RE: PCN # ESU270-34 -- SP3030-01ETG, SP3031-01ETG SP3021-01ETG and SP3022-01ETG Alternative Manufacturing Location Approval for Wafer Foundry & Backend Assembly, Test and Packing

## Product/Process Change Notice (PCN)

**PCN#:** ESU270-34    **Date:** Dec 4, 2015

# PCN Report

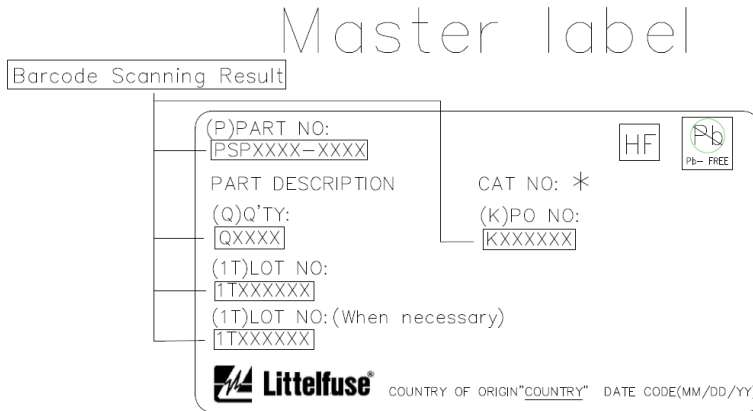
- 8.1 Wafer site can be identified by coding LOT NO on the label.
- 8.2 Assembly site can be identified by coding of CAT NO on the label.

Seq	P/N	Assy Catalog
Original	SP3031-01ETG	S
	SP3030-01ETG	S,H,X
	SP3022-01ETG	H,G
	SP3021-01ETG	G
New	<b>SP3031-01ETG</b> <b>SP3030-01ETG</b> <b>SP3022-01ETG</b> <b>SP3021-01ETG</b>	<b>T,G,H,S,X</b>
